# Service Manual

*Supplement*

**KX-TS2388CAB/KX-TS2388CAW/  
KX-TS2388RUB/KX-TS2388RUW/  
KX-TS2388UAB/KX-TS2388UAW/  
KX-TS880B/KX-TS880W/  
KX-TS880LXB/KX-TS880LXW/  
KX-TS880MLW/KX-TS880MXB/  
KX-TS880MXW/KX-TS880NDB/  
KX-TS880NDW/KX-TS880SAW/  
KX-TS881MXB/KX-TS881MXW/  
KX-TS889MXW/KX-TS108W**

Integrated Telephone System

KX-TS880 SCHEMATIC DIAGRAM (Main)

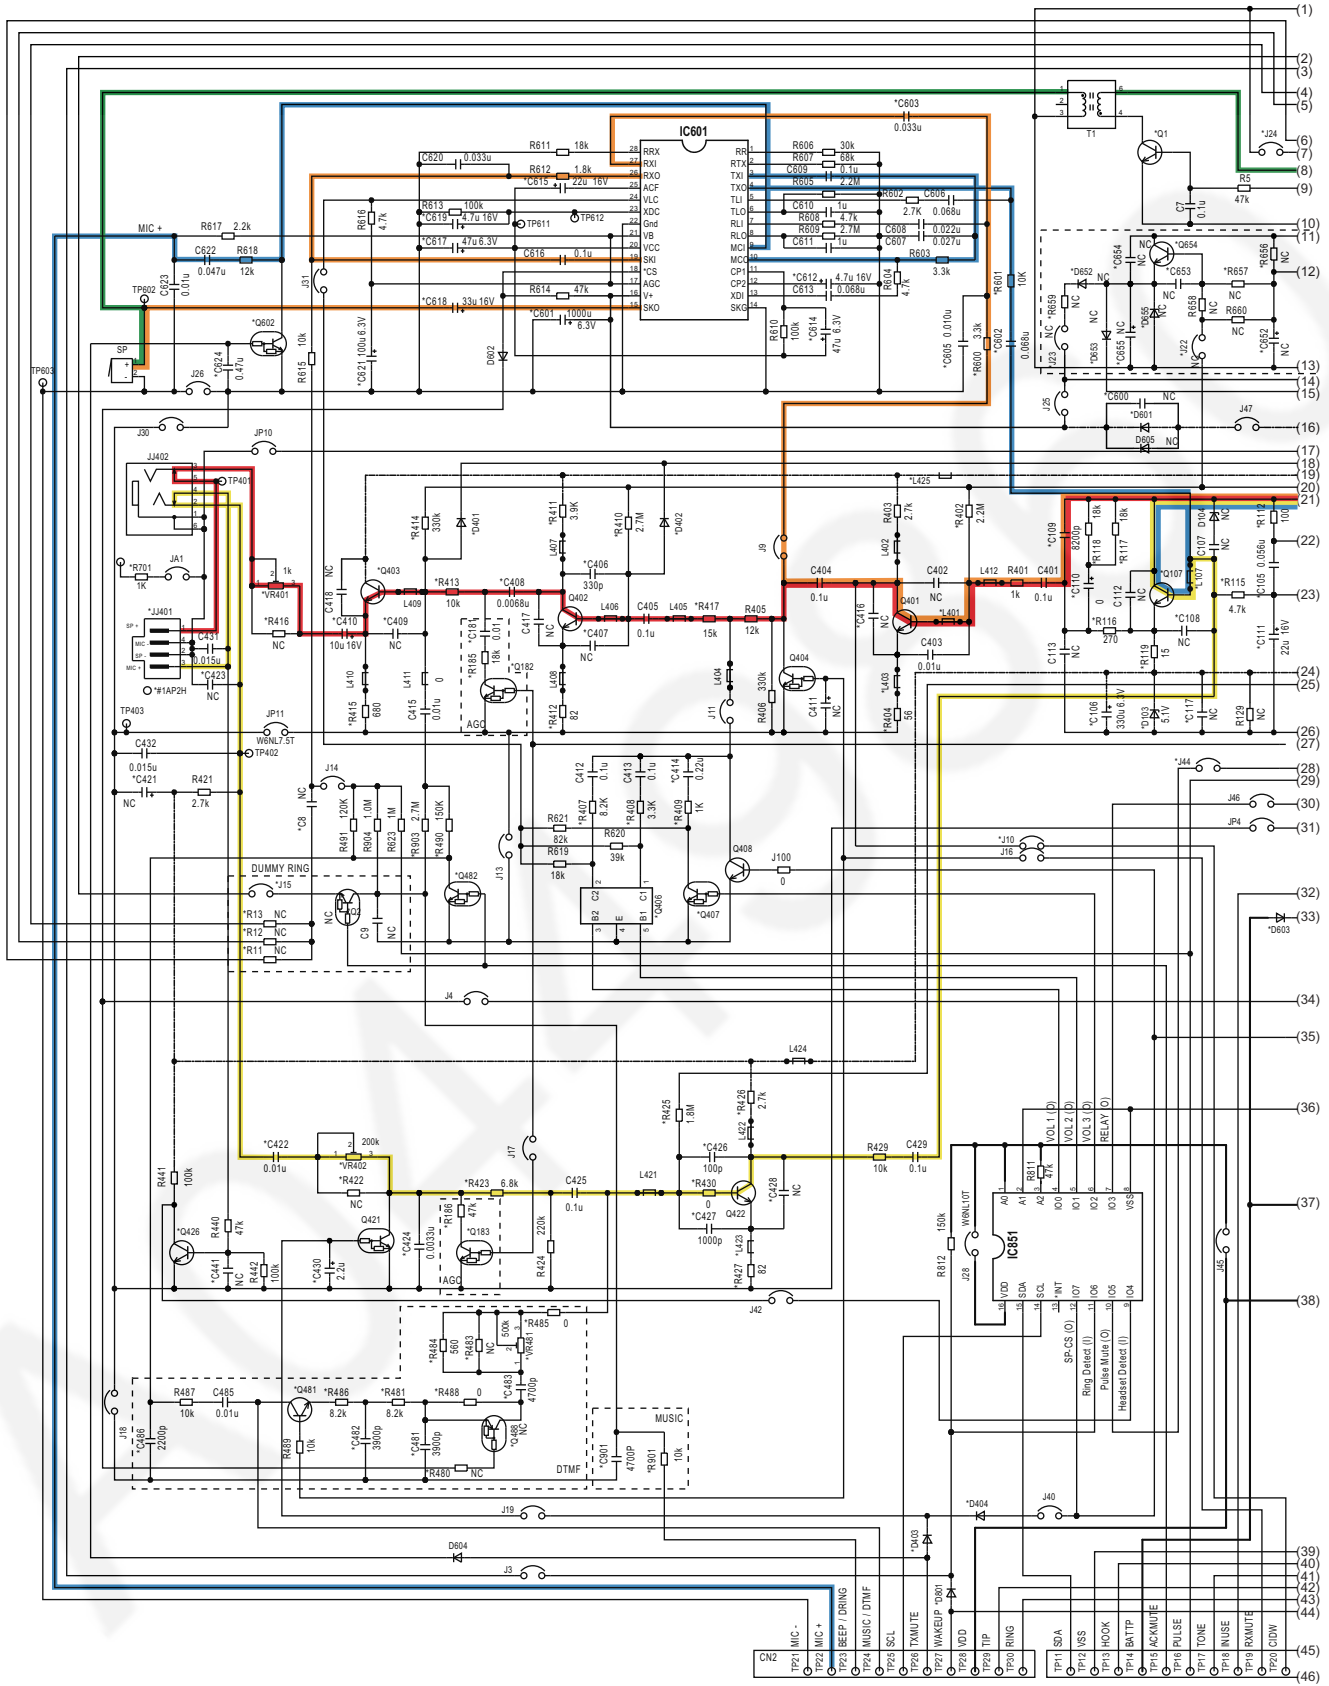
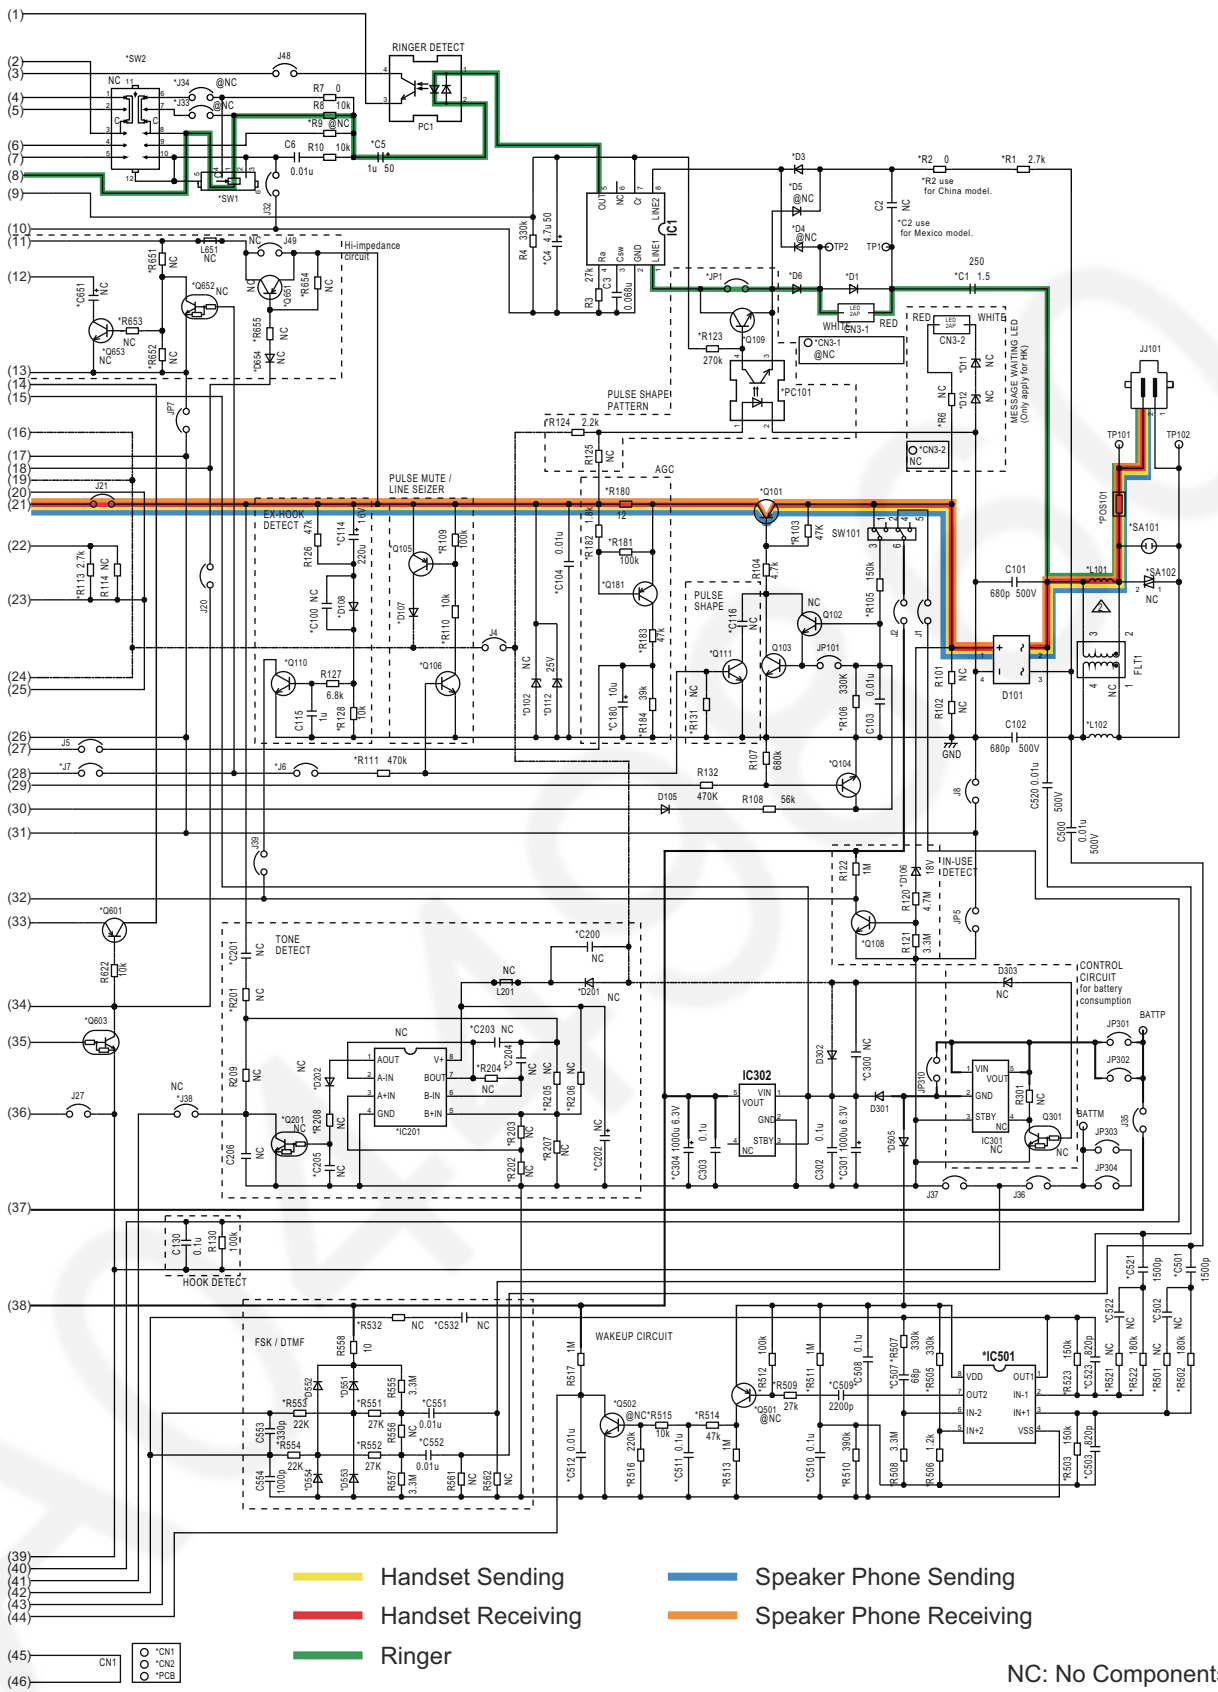
[Changed from original section "11.2. Schematic Diagram (Main)"]

NC: No Components  
 KX-TS881 SCHEMATIC DIAGRAM (Main)

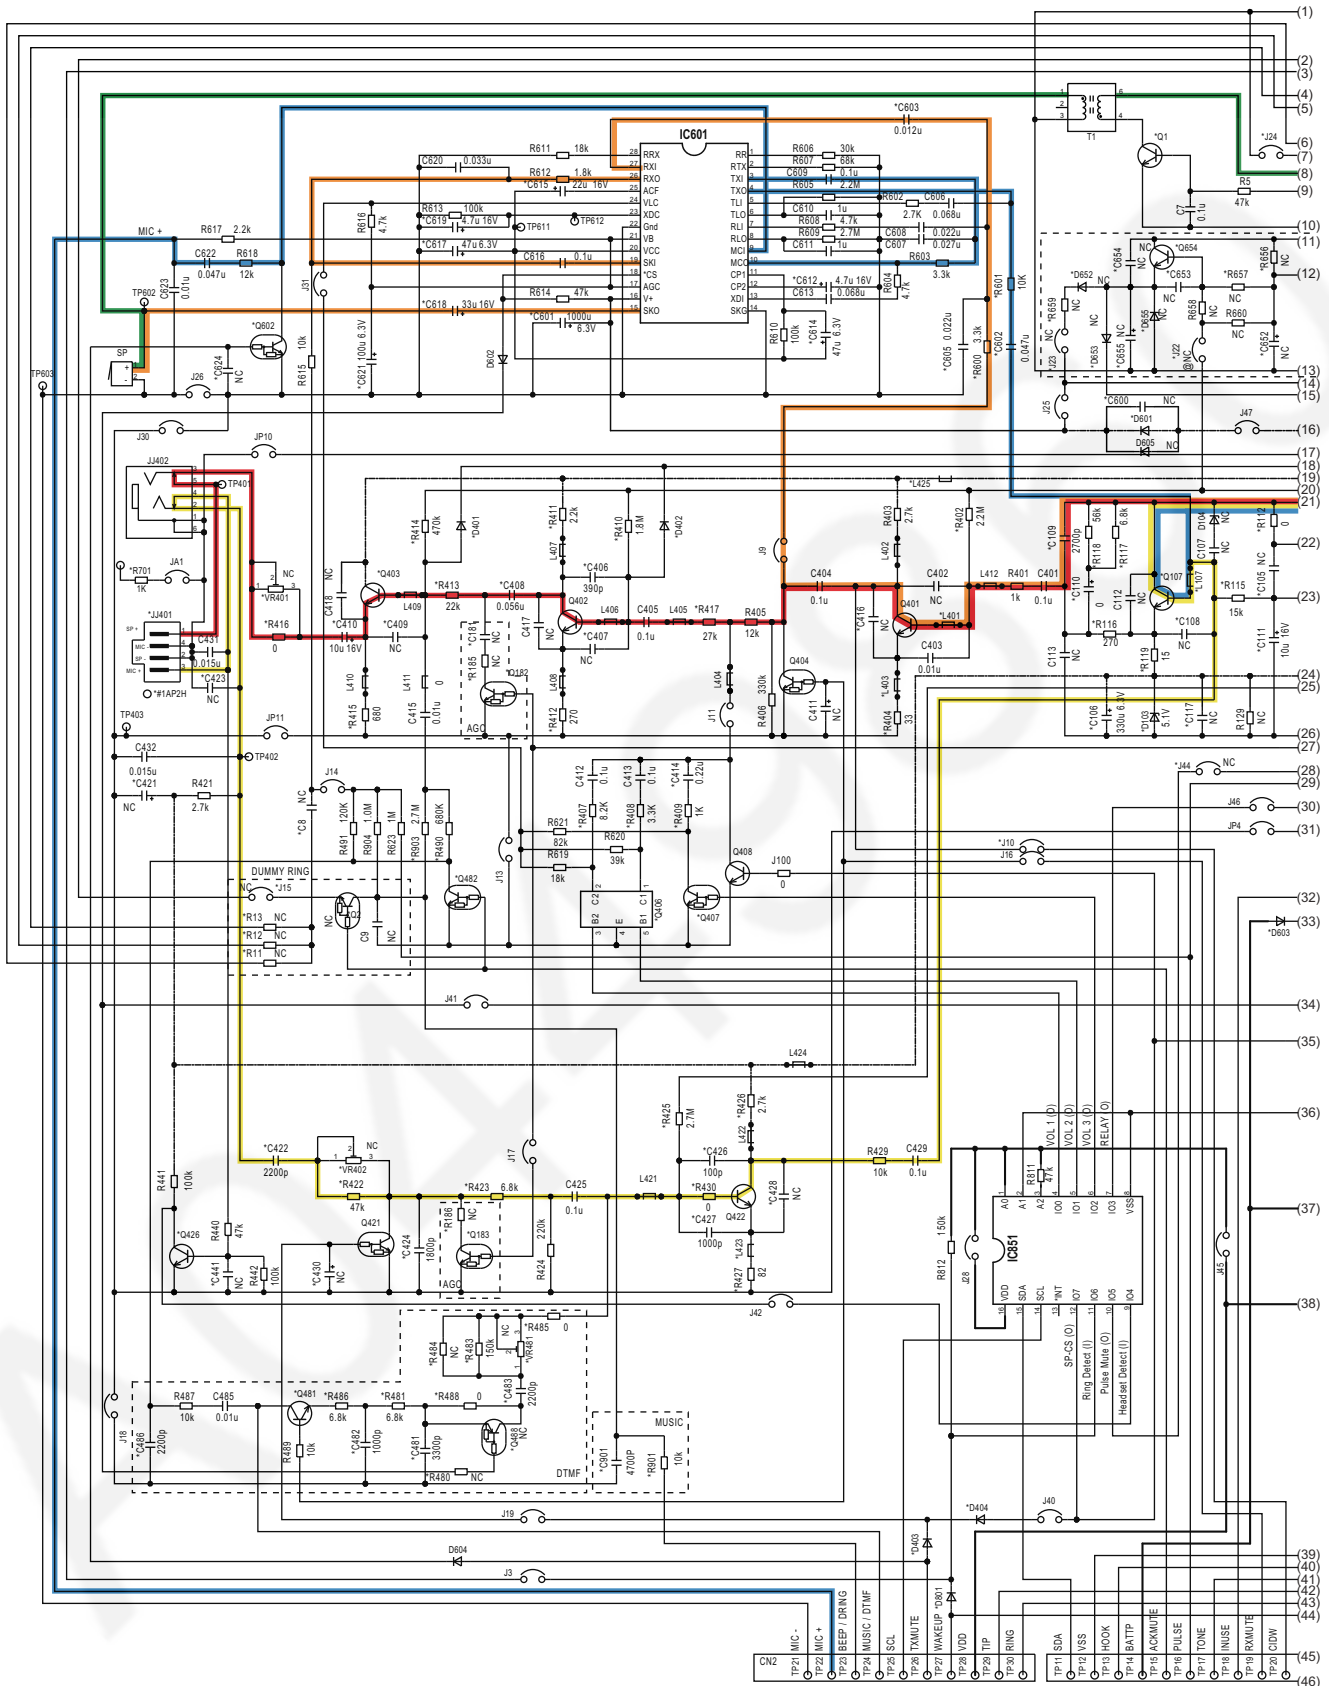
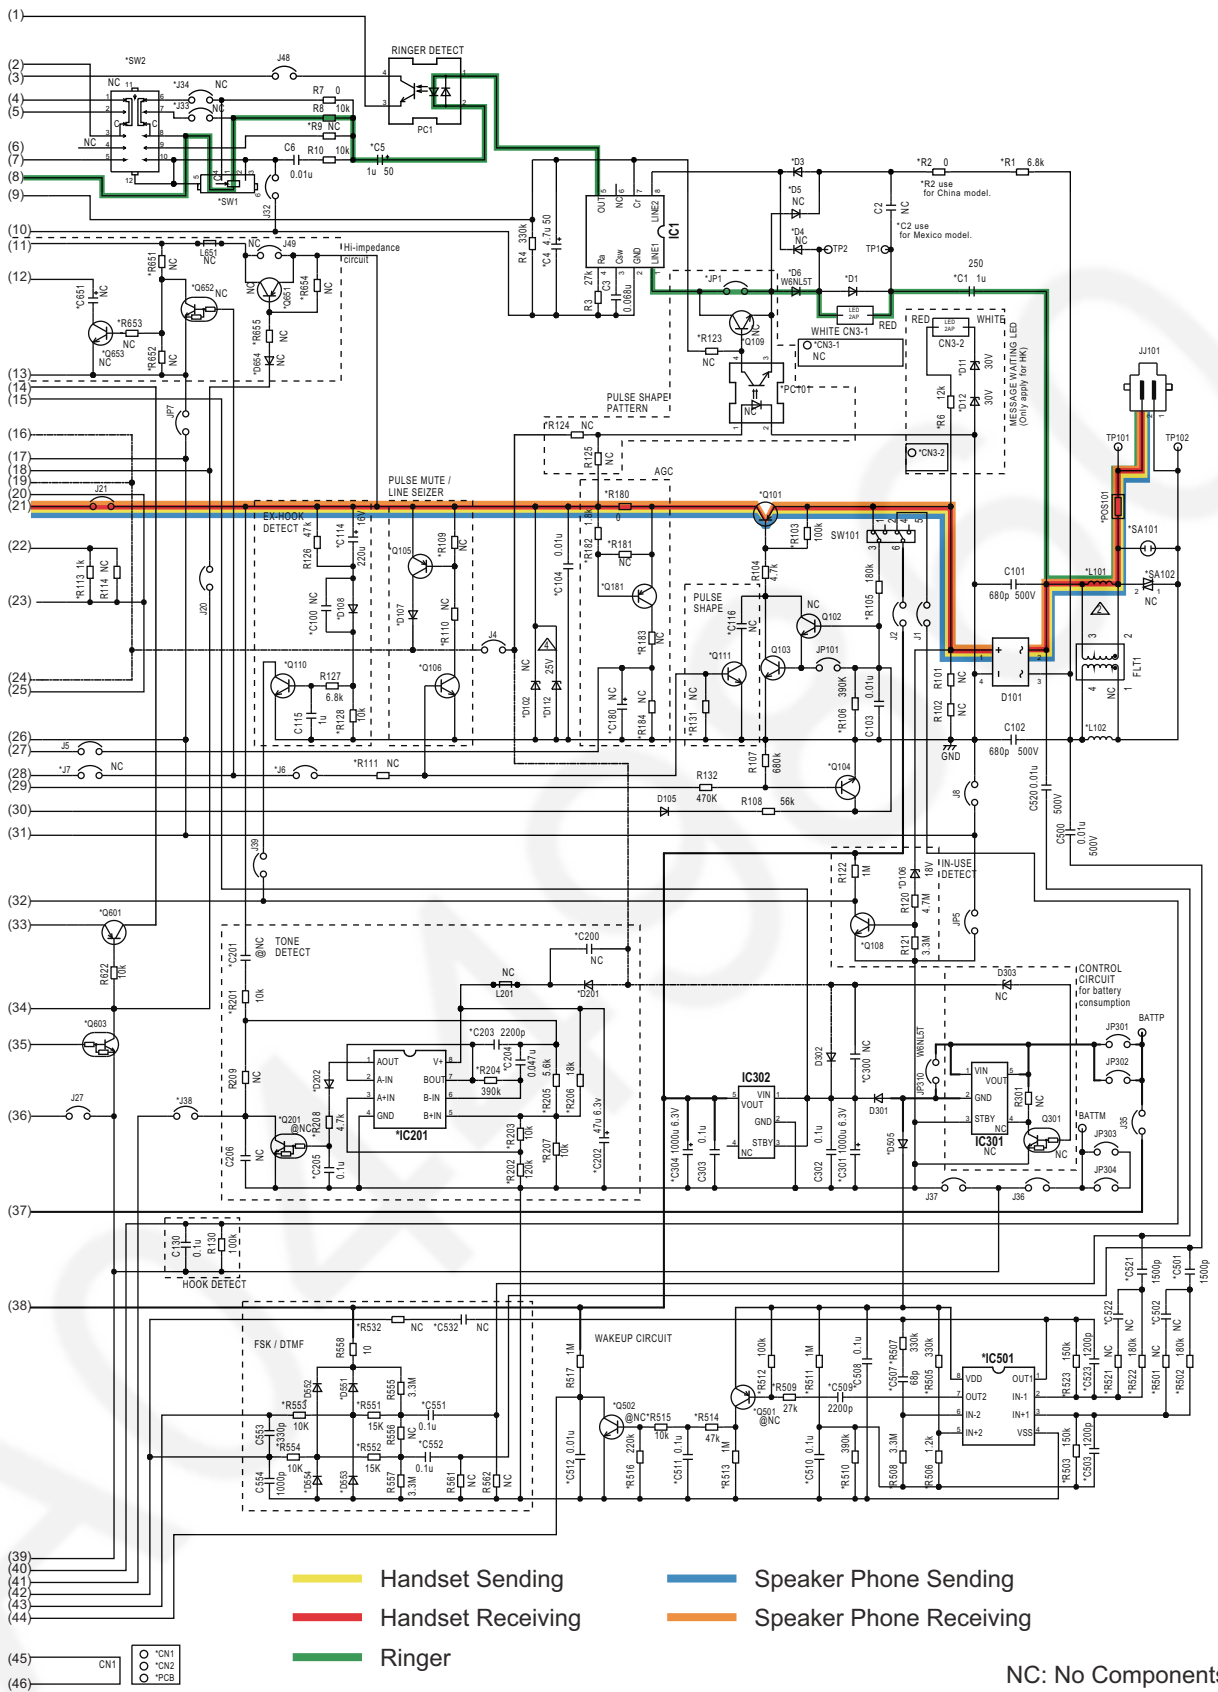
[Changed from original section "11.2. Schematic Diagram (Main)"]
